VISIT TO THE BASALT WASTE ISOLATION PROJECT (BWIP) HANFORD, WASHINGTON

DIVISION OF WASTE MANAGEMENT
U.S. NUCLEAR REGULATORY COMMISSION

NOVEMBER 1981

Figure 1

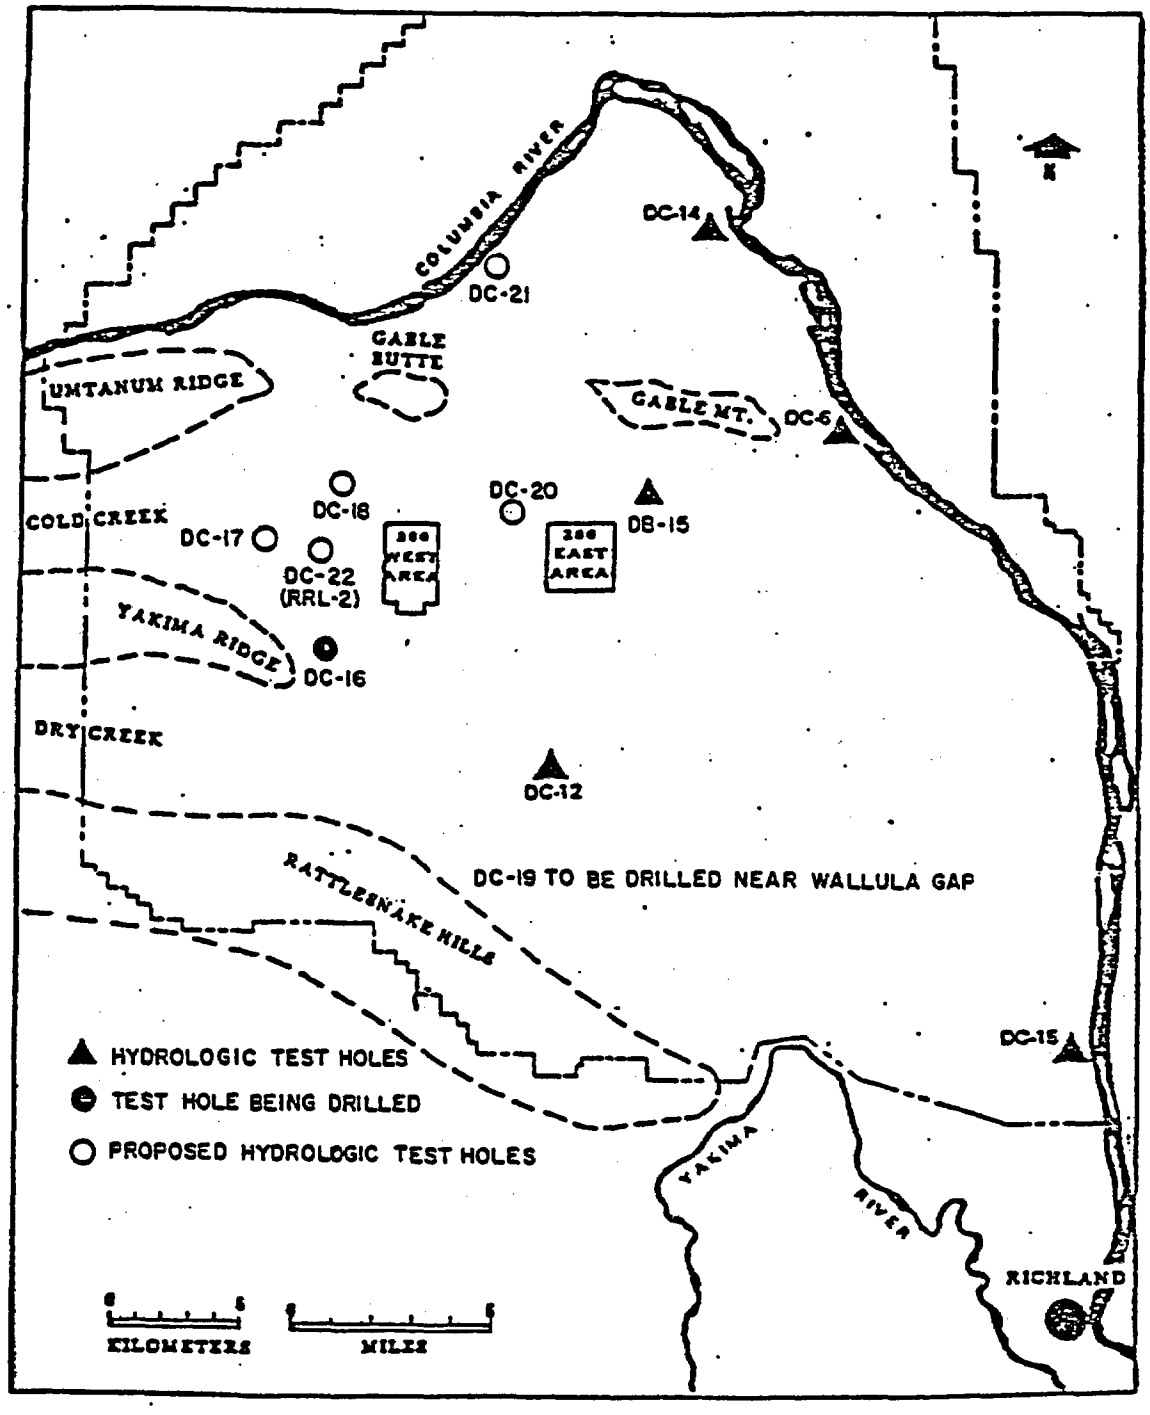
Plans for the next five years call for the drilling and testing of six small diameter core holes (Figure 1). Paired hole testing of the Umtanum by low volume pumping is planned in DC-4 and DC-5 and/or DC-7 and DC-8. The distances between these pairs of holes is less than 150 feet, and the holes are more than 5 miles from the RRL. While the data from the planned paired hole testing will be helpful, the value will be limited for several reasons. (1) Because of the close spacing of hole pairs (less than 150 feet) only a limited volume of rock will be tested. (2) Casing presently in the holes restricts testing to the Grande Ronde; no properties of higher units will be measured. (3) In view of the distance between the holes and the RRL, and the expectable lateral variation within the Umtanum, it is questionable whether the test values for the Umtanum can be applied to the RRL.

Figure 2

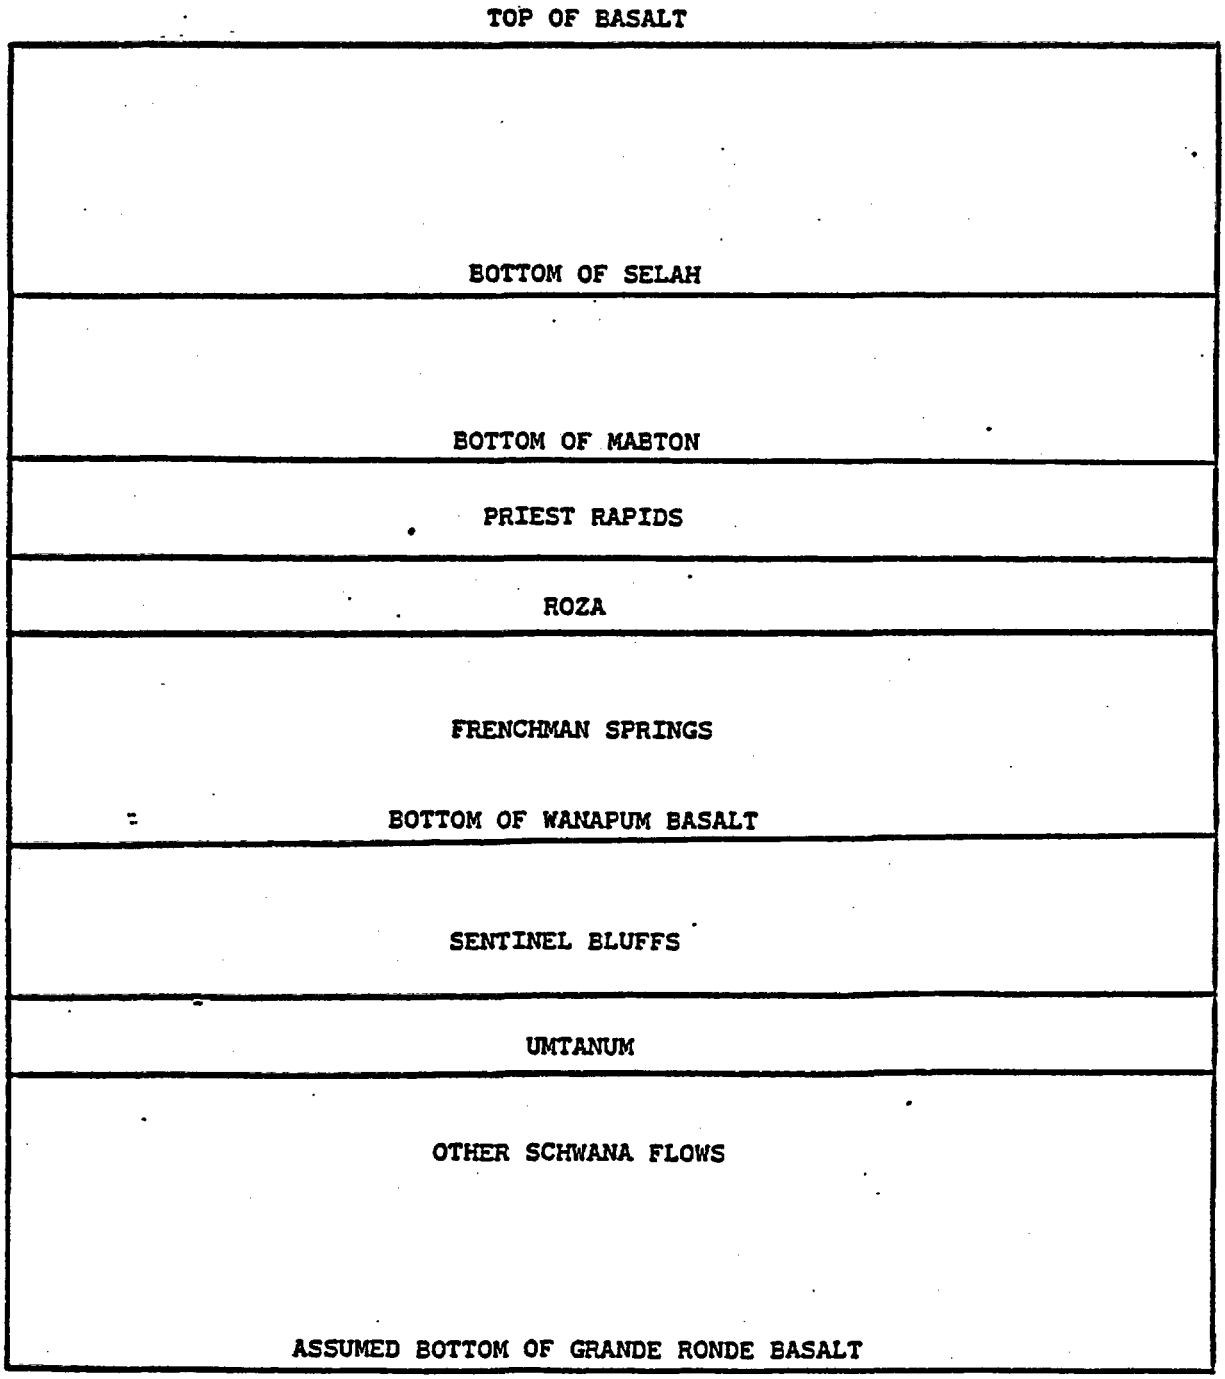
Conclusions drawn by RHO from the study are: (1) flow from the Saddle Mountains formation and possibly from the upper Wanapum formation discharges to the Columbia and Snake Rivers; (2) lower formations may discharge at Wallula Gap or beyond, with no apparent connection with the Columbia River outside of Wallula Gap (This may be due solely to choice of boundary conditions); and (3) the composited layering scheme is not conservative and more layers are needed to accurately calculate travel times. Figure 2 shows the layering scheme proposed for the multilayer model.

NWRB REPOSITORY LAYOUT (FIGURE 1)

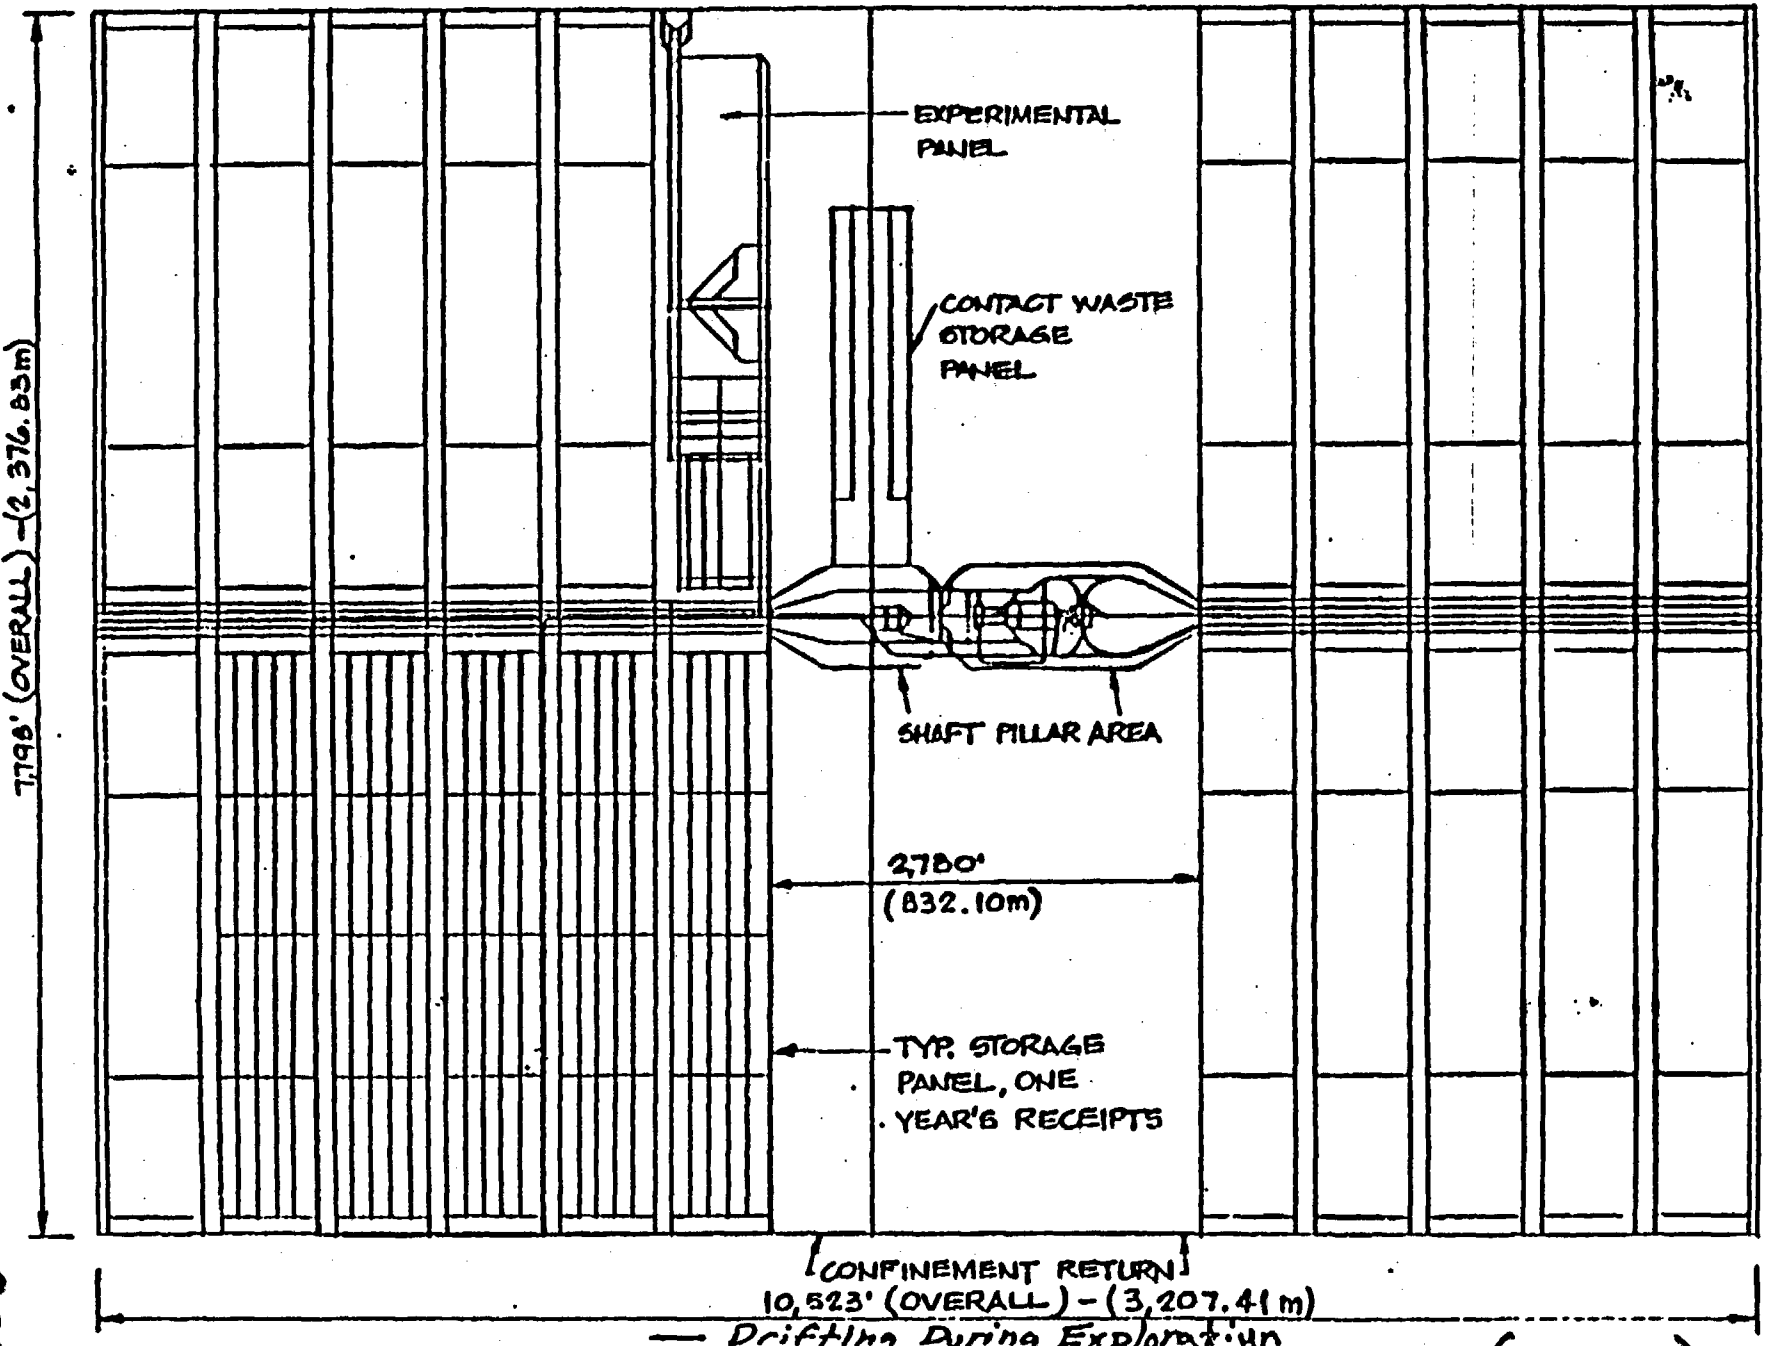
The proposed repository layout incorporates a substantial shaft pillar between two main storage areas. This pillar, 7800'x2730', will contain the five main repository shafts, the contact waste storage panel, and the ESTF (Figure 1). The exact location of the ESTF within the shaft pillar has not been specified. It is our opinion that this is the correct decision, and that the shaft pillar is sufficiently large to contain the ESTF without jeopardizing the performance of the repository. Information obtained from this initial entry into the repository horizon will provide a base with which to compare and evaluate the results of ongoing exploration drilling and development activities, which are an essential part of repository design verification.

(FIGURE 2)

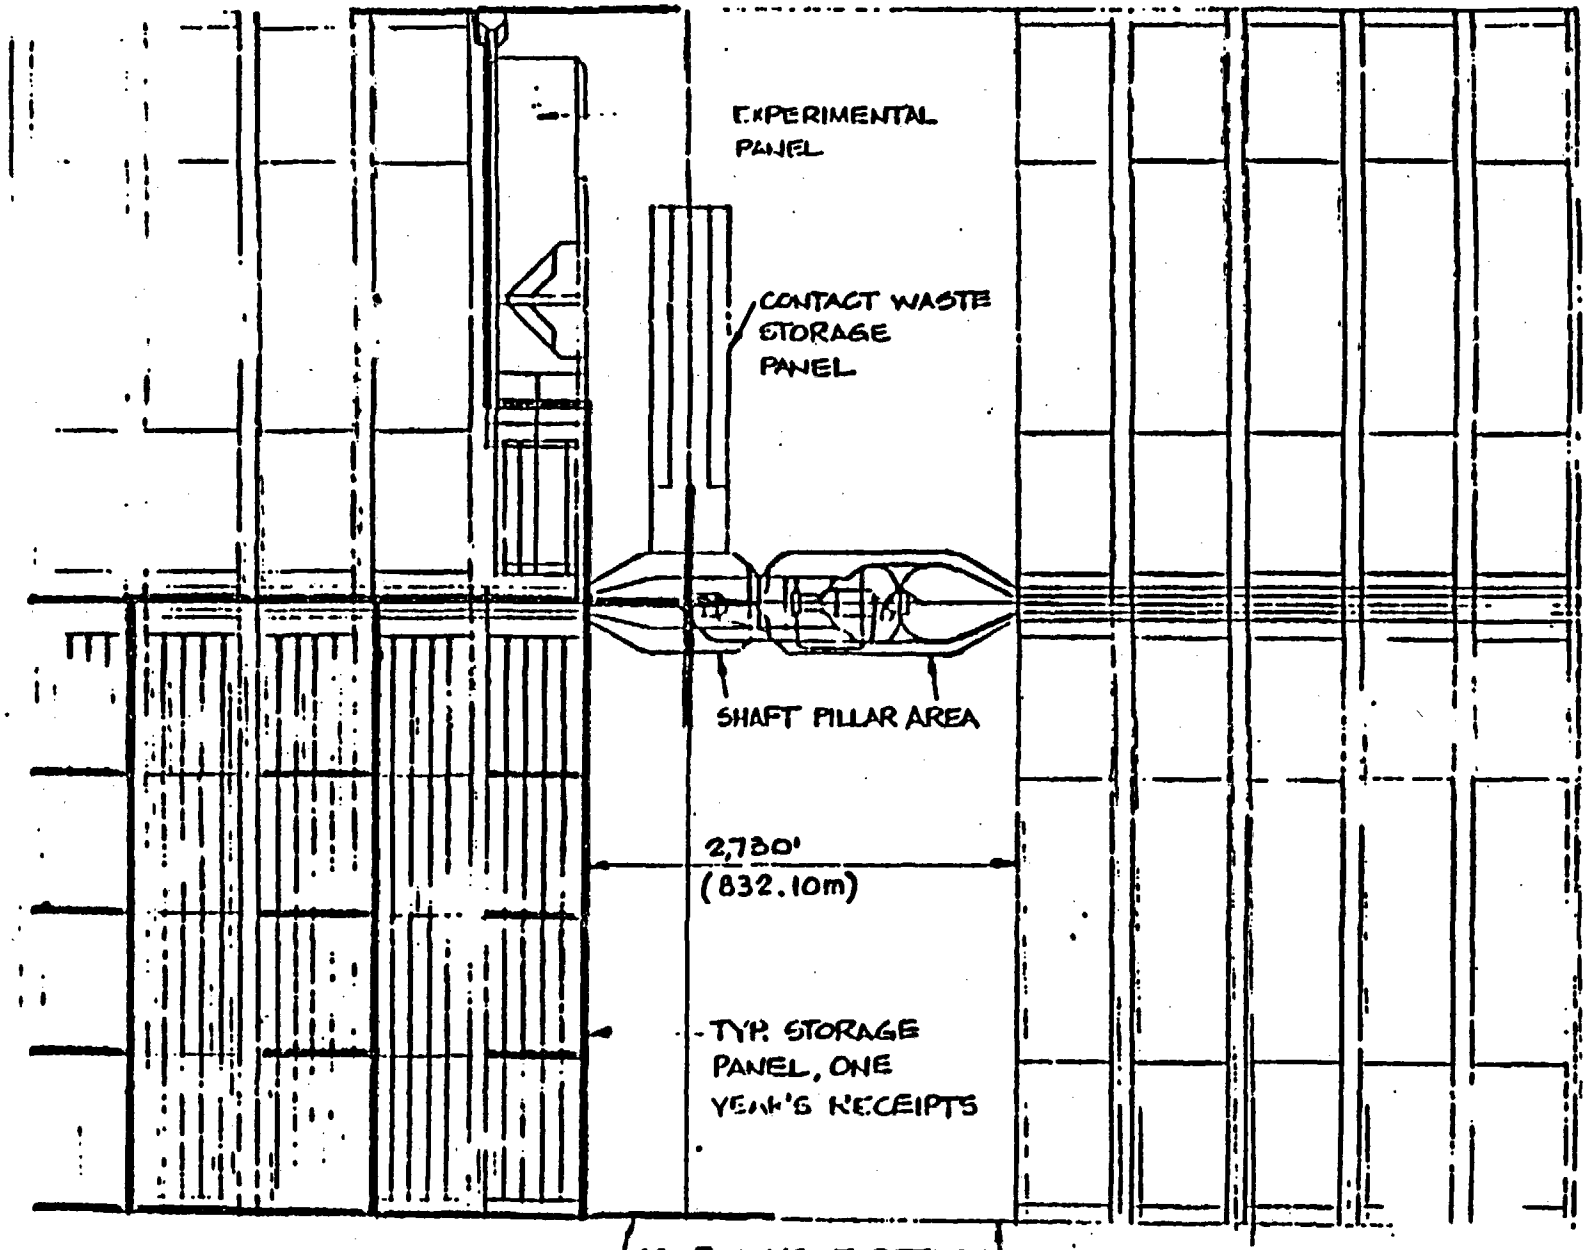
It is not clear at this point whether or not these two elements would precede construction authorization. As this development work provides a substantial part of site verification, the timing is crucial. This is an issue that should be discussed further with DOE. This total program of work will provide fairly detailed geological data over an area of 5 storage panels (equivalent to 5 years of waste storage), the experimental storage panel and the shaft area (Figure 2).
